Report date range from: 11/9/2023 12:00:00 PM to: 11/14/2023 5:00:00 PM

**PH 1 - 4. CD-1 Rezoning: 3231-3245 Fraser Street and 675 East 17th Avenue - Oppose**

SPRING EQUINOX Shadow Studies NOAA Solar Calculator

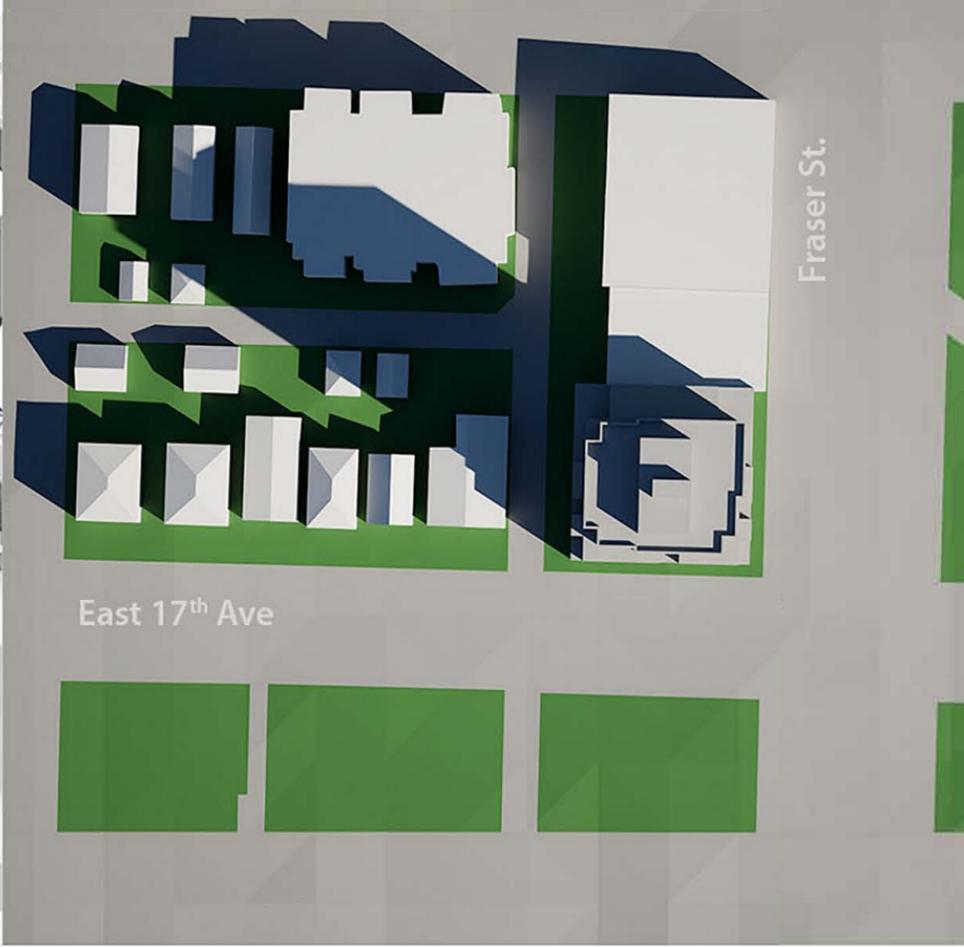
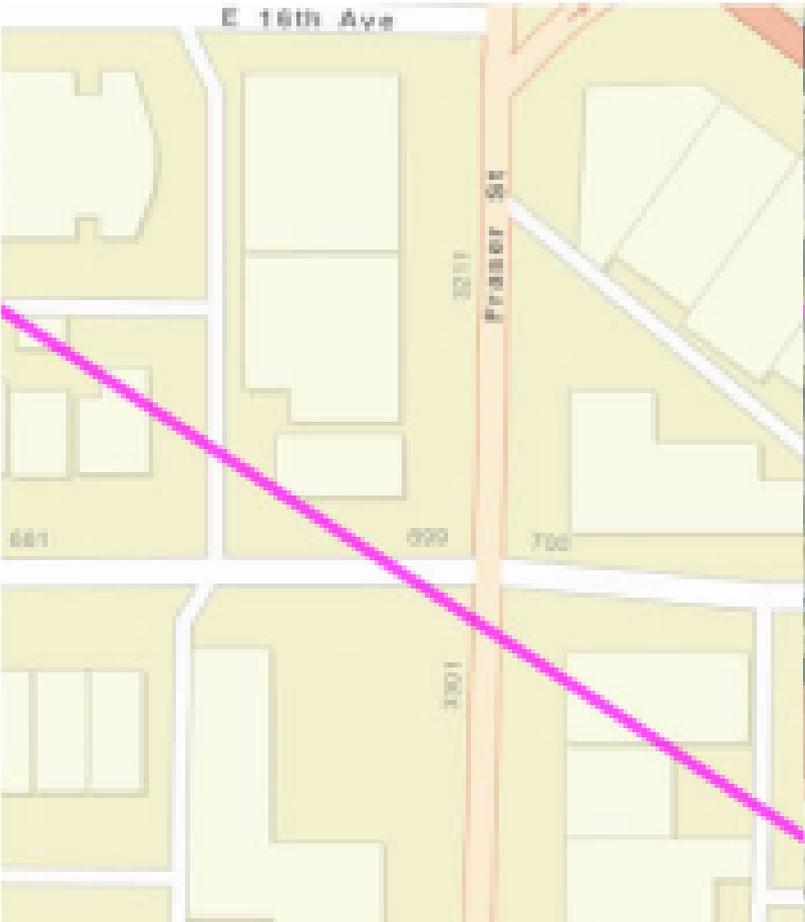
Date Received	Time Created	Subject	Position	Content	Author Name	Neighborhood	Attachment
2023-11-14	11:40	PH 1 - 4. CD-1 Rezoning: 3231-3245 Fraser Street and 675 East 17th Avenue	Oppose	<p>Dear Mayor and Council,</p> <p>I would like to ask you to oppose this rezoning application. It's much too high for this section of Fraser Street. The prevailing zoning of 3-4 storeys in C-2, with up to 6-storeys for rental buildings is what a development should be coming in at. I do know the area well as a former resident who lived in the vicinity of the rezoning on the southern edge of Mount Pleasant. The referral report appears to include a series of incorrect shadow diagrams. I'm surprised about this; however, it has happened before, with the 1477 West Broadway rezoning. For a point of reference, please find attached a screenshot from the NOAA solar calculator that shows the direction of shadows at 10am on March 20th. For Council's reference, I have also included a rough block massing model of the proposal with shadows at March 20 at 10am on all of the renderings apart from one that shows 9:45am on December 22nd. This proposal would make a profound impact on public views of the North Shore while heading north on Fraser Street as well as potentially set a precedent for the immediate area.</p> <p>Thank you for your consideration.</p> <p>Sincerely, Stephen Bohus, BLA</p> <p>The main massing model used here was completed north of 16th Avenue (for the Broadway Plan area), additional approximate massing of the block between Carolina and Fraser Street and 16th and 17th Avenues was added. The City of Vancouver is currently not making the internal 3D building files available via FOI. Staff should be able to do similar studies in house.</p>	Stephen Bohus, BLA	Grandview-Woodland	Appendix A
